SUPPLEMENTAL INFORMATION REPORT FOR THE
SOUTH SAN FRANCISCO BAY SHORELINE PROJECT

Santa Clara County, California

13 July 2021

Figure 3. Previously described haul routes associated with the proposed action

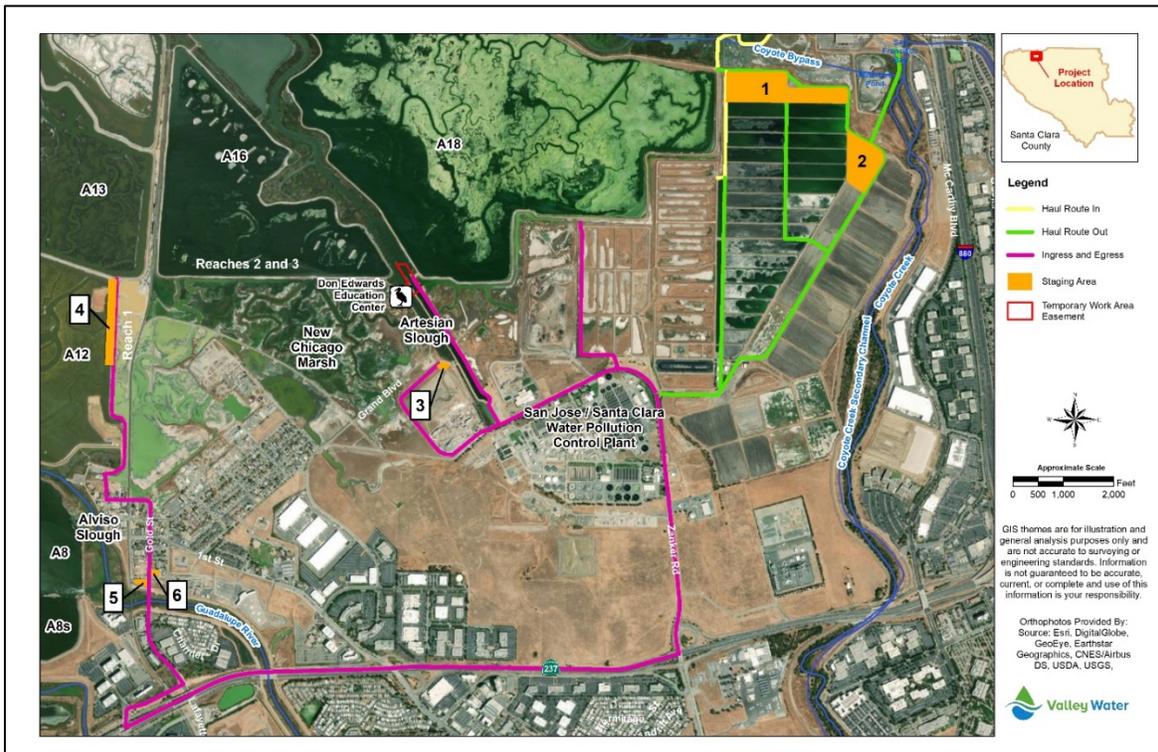
The haul route to Reach 1 was subsequently revised to avoid adding truck trips to North First Street along which community facilities such as library, fire station, and elementary school are located such that haul trucks would access Reach 1 via State Route 237 to the Lafayette Street/Great America Parkway, the Gold Street Connector to Gold Street, continuing on to Elizabeth Street, then to Hope Street and into the Alviso Marina County Park. This change was identified, and its effects were evaluated in the 2020 SIR's Transportation Section (Section 4 of the 2020 SIR – Revised Impact Analysis), however a description of the change was inadvertently left out of Section 3 of the 2020 SIR (changes to the proposed action). These previously identified haul routes are shown in Figure 3.

Additionally, the 2015 IFR described the potential haul route to the Reaches 2 & 3 site and associated staging area #3 as being accessible from the Zanker Landfill entrance. However, staging area #3 can only be accessed through Grand Boulevard; it is inaccessible from the Zanker landfill. Thus, the Reaches 2 & 3 site at the EEC and staging area #3 would need to be accessed through Zanker Road, Los Esteros Boulevard, and then north along Grand Boulevard. Figure 4 shows this clarified route as a red dashed line. The clarified route would not result in any change in construction activities other than utilizing a slightly different path to transport materials in and out of the project at Reach 2 & 3. The 2015 IFR already identified and evaluated effects of construction traffic traveling along Zanker Road and Los Esteros Boulevard to access the project site and evaluated direct and indirect effects to access to the EEC and the EEC itself during levee construction due to increased traffic, noise, and dust associated with construction access to the work area (p.4-514 - 4-516). Accessing the project site through the clarified route would result in the same traffic and noise impacts as previously evaluated because trucks would

Figure 4. Additional alternative haul route along Grand Boulevard and North First Street.

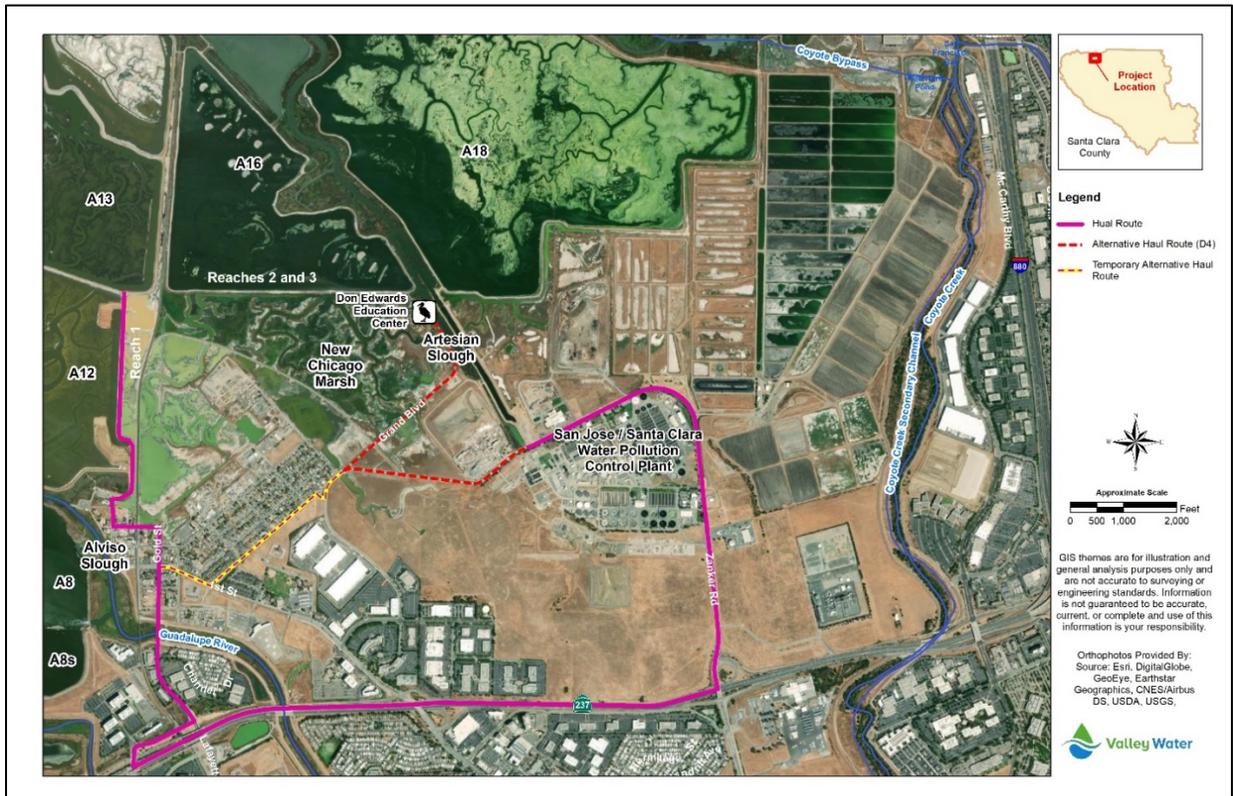
Subsequent to the 2020 SIR, the USACE and Valley Water identified a shorter alternative haul route between the Reach 1 site at the Alviso Marina and the Reaches 2 & 3 site at the EEC. This would be an alternative route that would provide the contractor the option to reduce truck trip distance. The alternative haul route would run from the Reach 1 site along the existing haul route (pink solid line in Figure 4) to south of Hope Street, left on Elizabeth Street to Gold Street, then would deviate from the existing route by going left on North First Street (dashed red-yellow line in Figure 4) and on to Grand Boulevard all the way to the Reaches 2 & 3 site by the EEC (dashed red-yellow and dashed red lines along Grand Boulevard in Figure 4). The alternative haul route could also be used in the reverse direction from the Reach 2 & 3 site to the Reach 1 site.
